Well Name: LOGAN 35B FEDERAL	Well Location: T17S / R27E / SEC 35 / SESW /	County or Parish/State: EDDY / NM
Well Number: 8	Type of Well: OIL WELL	Allottee or Tribe Name:
Lease Number: NMLC028755A	Unit or CA Name:	Unit or CA Number:
US Well Number: 300153044000S2	Well Status: Producing Oil Well	Operator: REDWOOD OPERATING LLC

Type of Action Plug and Abandonment

## PLUG AND ABANDONMENT CONDITIONS OF APPROVAL

OPERATOR'S NAME:	Redwood Operating LLC
LEASE NO.:	NMLC028755A
WELL NAME & NO.:	Logan 35B Federal 8
US Well Number:	300153044
LOCATION:	Section 35, T.17 S., R.27 E., NMPPM
COUNTY:	Eddy County, New Mexico

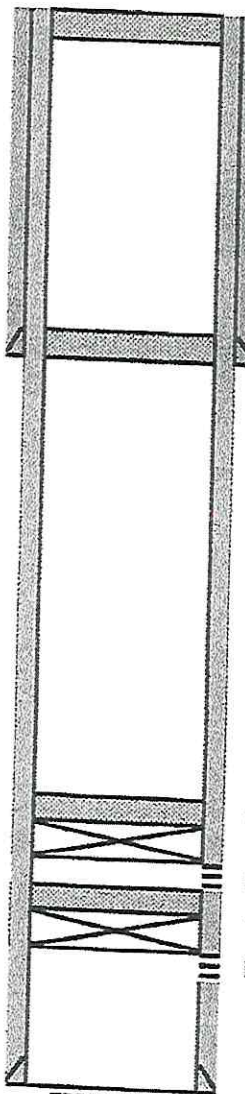
1. Tag 5 1/2" CIBP @ 3020'. ~~Dump bailed~~ 35' or spot 25 sx cmt @ 3020-2820'. *WOC \$74K*
2. Set 5 1/2" CIBP @ 1975'. Circ hole w/ MLF. Pressure test csg. Spot 25 sx cmt @ 1975-1775'. WOC & Tag.
3. Spot 45 sx cmt @ 1200-845'. WOC & Tag (8 5/8" Shoe & Queen)
4. Spot ~~25~~ <sup>55</sup> sx cmt @ ~~200~~ <sup>498</sup>' to surface. *Verify @ surface.*
5. Cut off well head, verify cmt to surface, weld on Dry Hole Marker.
